Service Bulletin

CBR650R/RA #1
Revised: February 2026

SAFETY RECALL

2024 - 2025 CBR650R/RA WIRE HARNESS SHORT CIRCUIT

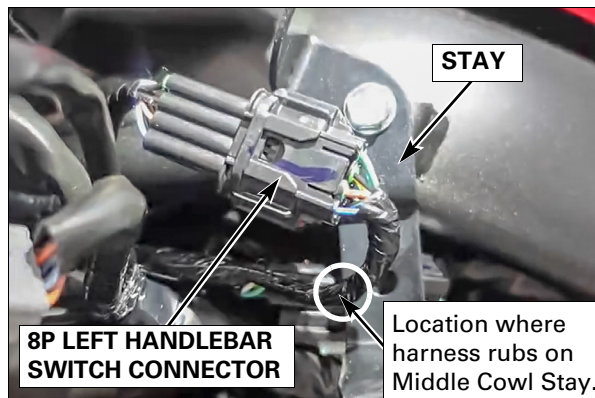
Inspect the Left Handlebar Switch Harness following the steps below to ensure there is ZERO wear or damage on the harness tape or wires near the middle cowl stay.

1. Disconnect the 8P Left Handlebar Switch connector.
2. Inspect the wire harness insulation in the location shown for signs of damage to the wire harness tape or wires.

- If there is no damage whatsoever to the harness, go to **Repair A** on [page 5](#).

- If there is wear or damage to the harness tape only, and there is no damage to any wire insulation, and no copper wires are visible, go to **Repair B** on [page 6](#).

- If there is visible damage to any wiring insulation, or the stranded copper wiring is visible or broken, go to **Repair C** on [page 7](#).

REPAIR A

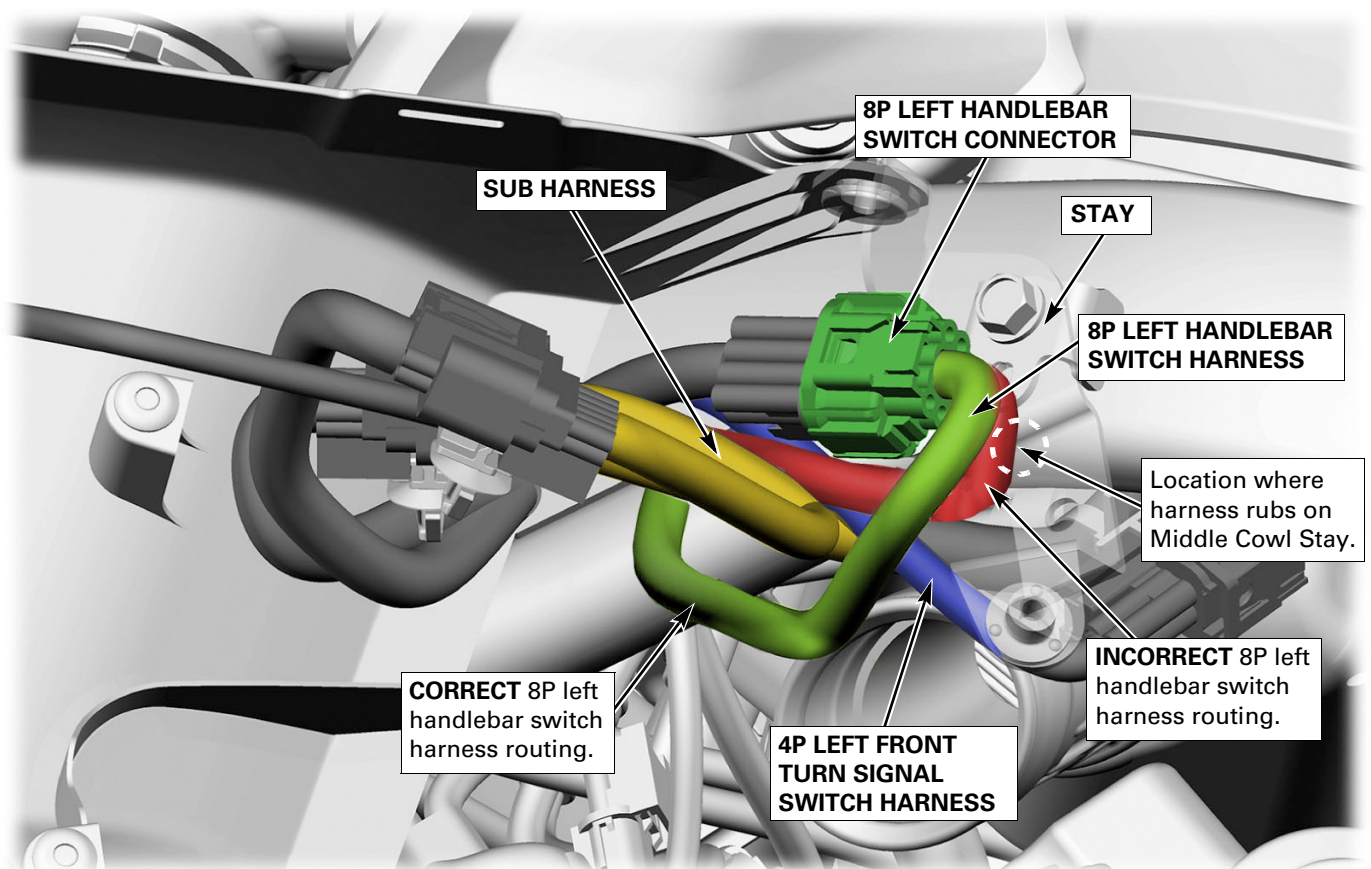
If no damage was found on the switch harness tape, reroute the harness following the steps below, and then file a **KT7A** warranty claim using the information shown in WARRANTY CLAIM INFORMATION on [page 2](#).

1. Route the 8P Left Handlebar Switch harness and connector (highlighted in green) underneath the front sub harness (highlighted in yellow).
2. Ensure the 8P Left Handlebar Switch harness and connector are routed in front of the 4P Left Front Turn Signal Switch Harness (highlighted in blue).
3. Slightly untwist and re-situate the Front Sub Harness, as demonstrated in the video link below.
4. Reconnect the 8P Left Handlebar Switch Harness connector.
5. Be sure the 8P Left Handlebar Switch harness does not contact the Left Middle Cowl stay.
6. Reassemble the motorcycle in the reverse order of disassembly.

REPAIR B

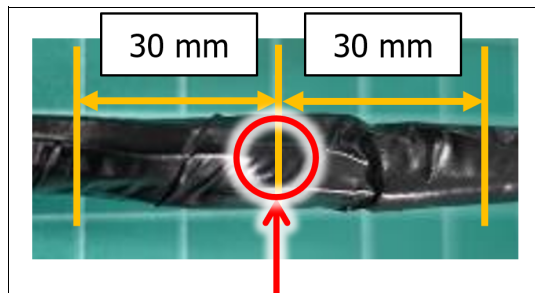
If there is wear or damage to only the harness tape, and no damage found on the wire insulation or stranded copper wire, apply additional electrical tape to the area shown, and then reroute the harness following the steps below. File a **KT7B** warranty claim using the information shown in WARRANTY CLAIM INFORMATION on [page 2](#).

1. Wrap new electrical tape over the existing harness tape:

- The new tape should extend 30 mm (1.2 in.) on both sides past the location where the damaged tape was found.
- Wrap the tape around the harness at least two or three times to ensure a proper protective covering for the wires.

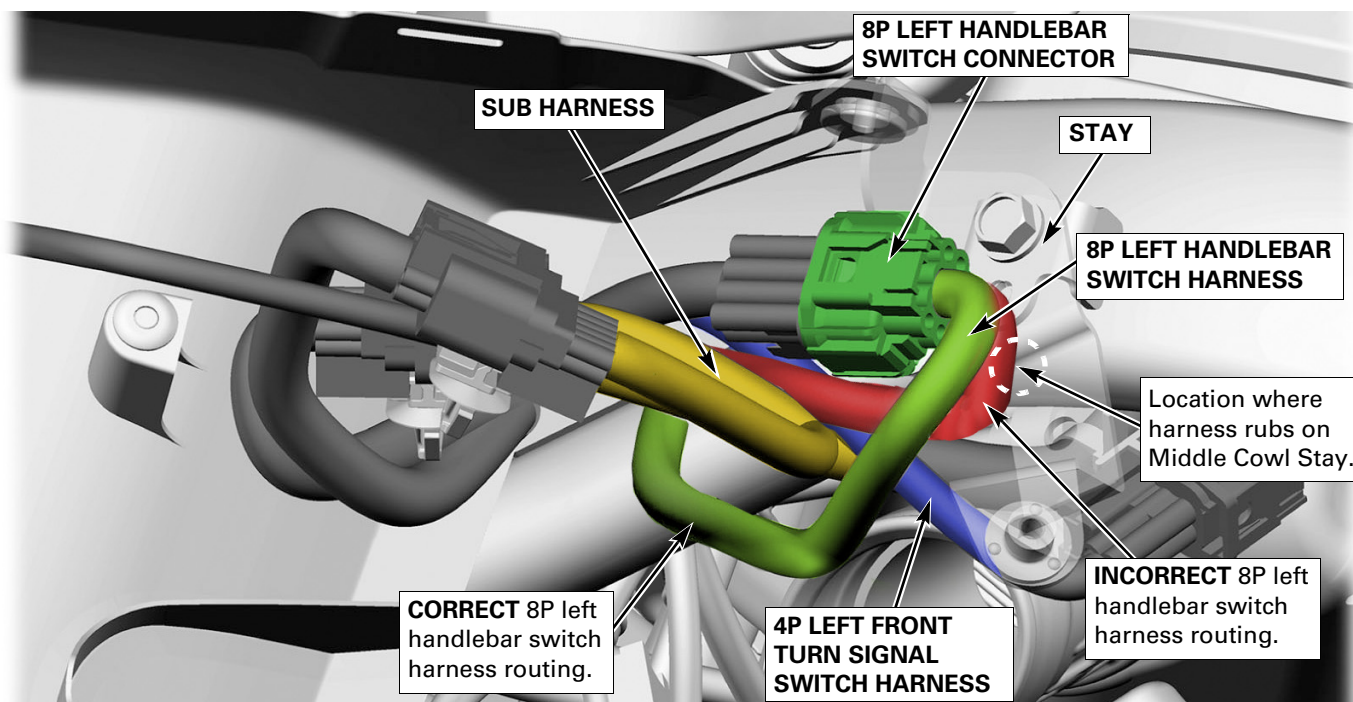
2. Route the Left Handlebar Switch harness and 8P connector (highlighted in green below) underneath the front sub harness (highlighted in yellow).

3. Ensure the Left Handlebar Switch harness and 8P connector are routed in front of the 4P Left Front Turn Signal Switch Harness (highlighted in blue).

4. Slightly untwist and re-situate the Front Sub Harness, as demonstrated in the video link below.

6. Be sure the Left Handlebar Switch harness does not contact the Left Middle Cowl stay.
